SERVICE PARTS LIST FOR MITSUBISHI ELECTRIC PACKAGED AIR-CONDITIONERS

Series : PFFY-P•NEMU-E
PFFY-P•NRMU-E

REVISED

BWE0512E

EXTERNAL PARTS (1)

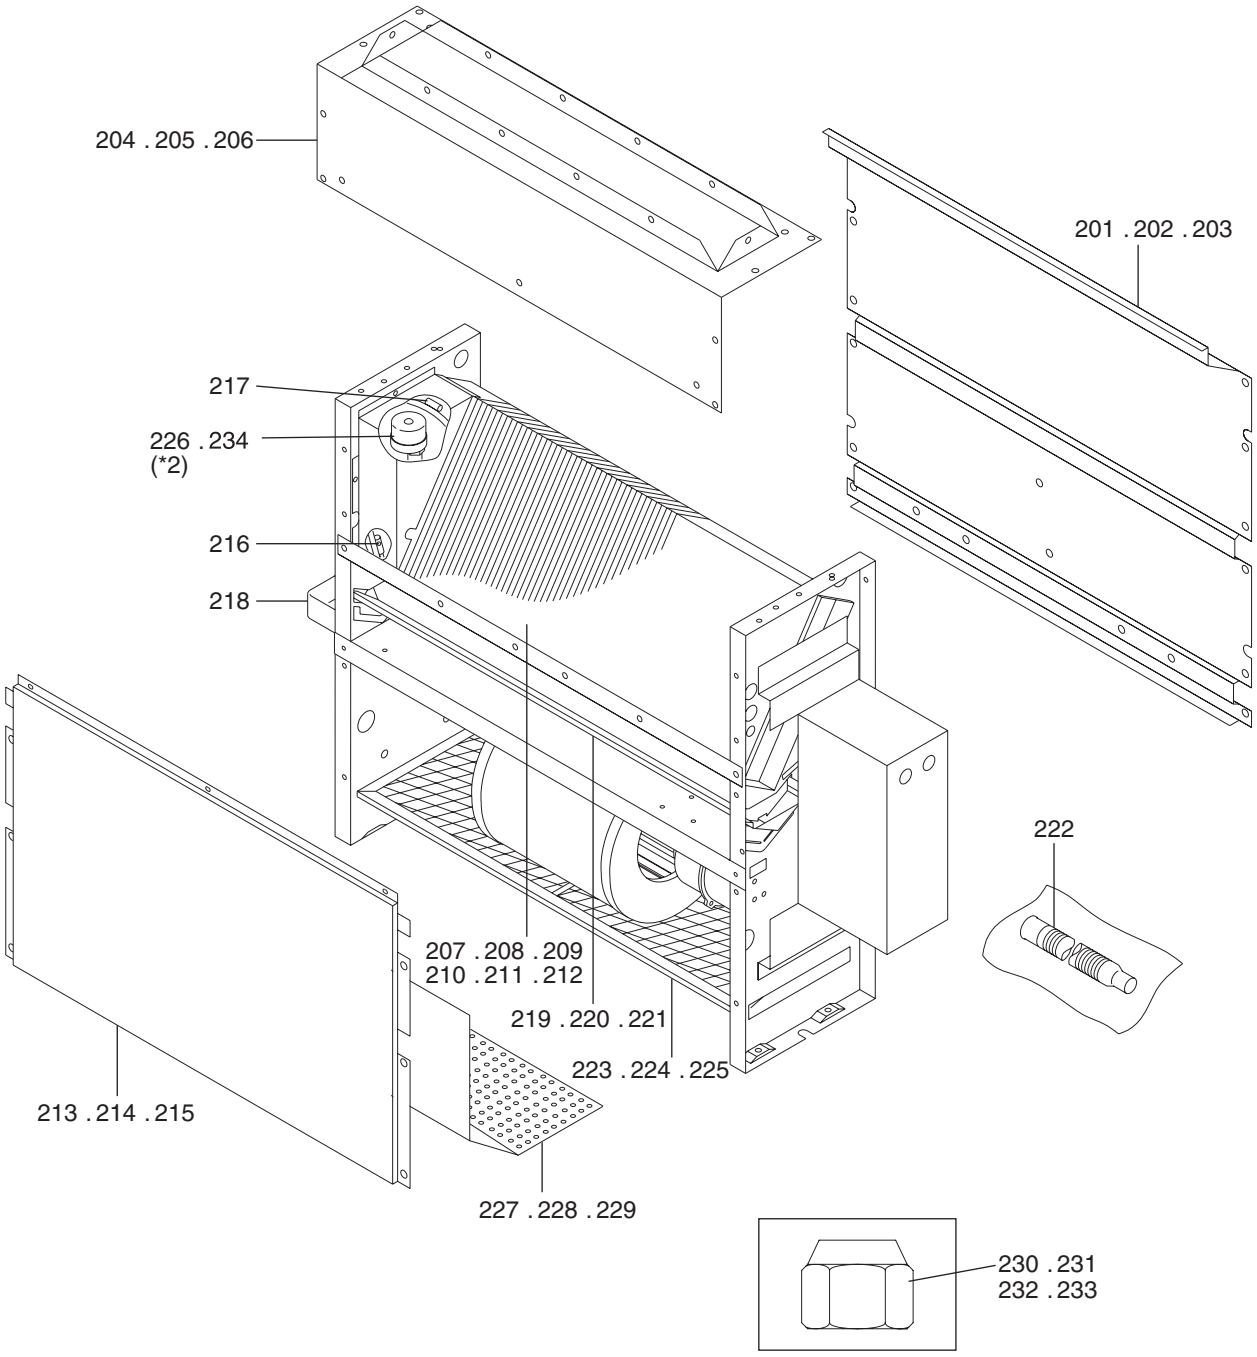
Please change the old catalog (issued Dec. 2015, BWE0512D) to this new catalog.
Content of revision : Some of parts are changed.

*1 Products manufactured in or before Aug. 2020 have the EFM-type LEV. Products manufactured in or after Sept. 2020 have the PAM-type LEV. Replace the EFM-type LEV with the PAM-type LEV, using parts 132 and 144.

131	R63 3E1 500	Filter						1	1	W275191G05		
132	R61 047 401	Linear expansion valve	PAM-B40YGMD-1	1	1	1	1	1	1	P632538X01	<LEV> *1	Chg.
133	R63 Y10 049	Switch panel		1	1	1	1	1	1	W657853H02		
134	R63 Y01 611	Fin guard		1	1					W622564G04		
135	R63 Y02 611	Fin guard				1	1			W622564G05		
136	R63 Y03 611	Fin guard						1	1	W622564G06		
137	R61 Y07 611	Guard	25	1	1					W258829G01		
138	R61 Y08 611	Guard	32.40			1	1			W258829G02		
139	R61 Y09 611	Guard	63					1	1	W258829G03		
140	R61 006 122	Flare nut	12.7(1/2)	1	1	1	1	1		KB21S918H01	gas	
141	R63 8G1 122	Flare nut	15.88(5/8)						1	KB21S919H01	gas	
142	R61 008 122	Flare nut	6.35(1/4)	1	1	1	1	1		KB21S916H01	liquid	
143	R63 8G0 122	Flare nut	9.52(3/8)						1	KB21S917H01	liquid	
144	R61 048 401	Solenoid valve coil	PAM-MD12MD-8	1	1	1	1	1	1	P472082X01	*1	Add.

EXTERNAL PARTS (2)

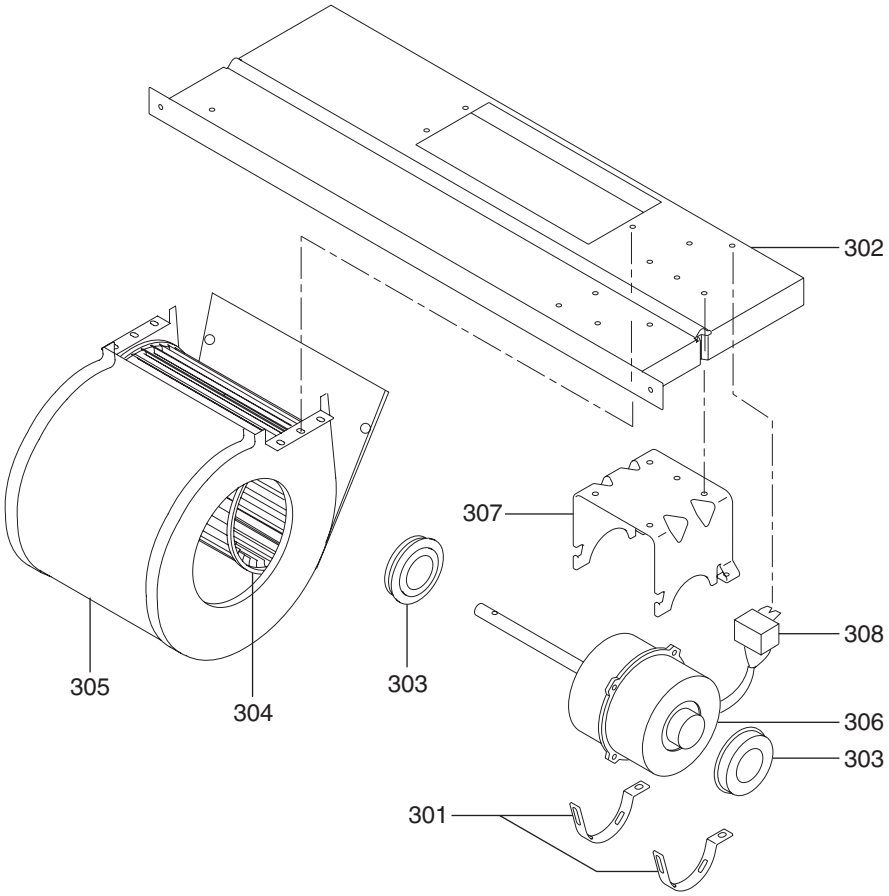
*2 Products manufactured in or before Aug. 2020 have the EFM-type LEV. Products manufactured in or after Sept. 2020 have the PAM-type LEV. Replace the EFM-type LEV with the PAM-type LEV, using parts 226 and 234.

232	R61 008 122	Flare nut	6.35(1/4)	1	1	1	1	1		KB21S916H01	liquid	
233	R63 8G0 122	Flare nut	9.52(3/8)						1	KB21S917H01	liquid	
234	R61 048 401	Solenoid valve coil	PAM-MD12MD-8	1	1	1	1	1	1	P472082X01	*2	Add.

CONTROL BOX PARTS

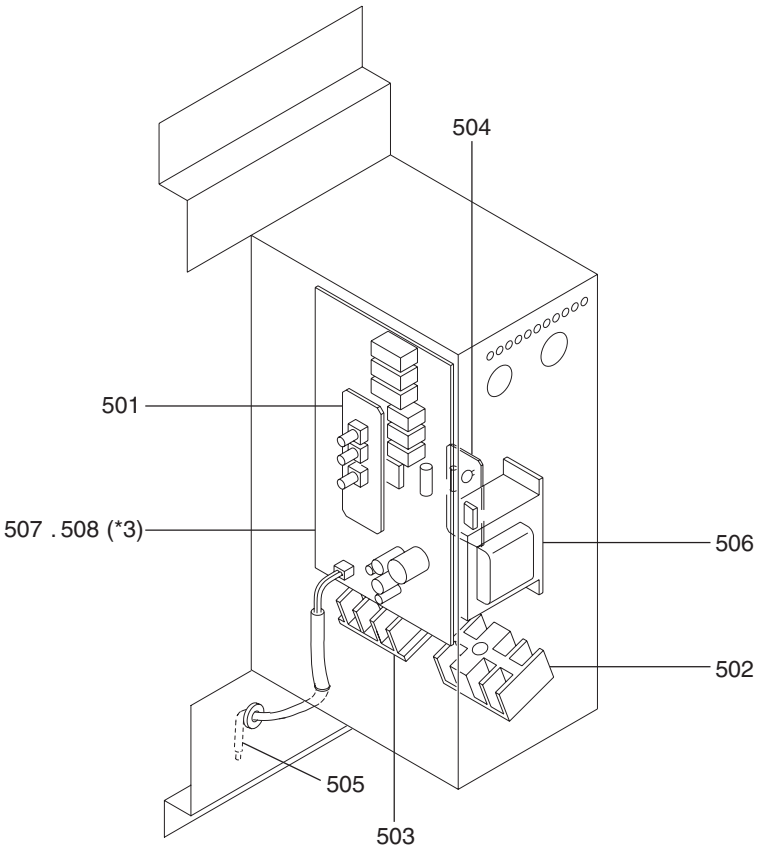
*3 For the products whose serial number is 5XW***** or later, be sure to use No.508.
For the products whose serial number is 59W***** or earlier, No.507 or No.508 can be used.
If the production number of the indoor unit is not available, procure parts No.508.
No.507 will be supplied as long as the stock is available,
and only No.508 will be supplied after the existing stock of No.507 is depleted.

～59W*****	5XW*****～
No.507	USE	NOT USE
No.508	USE	USE
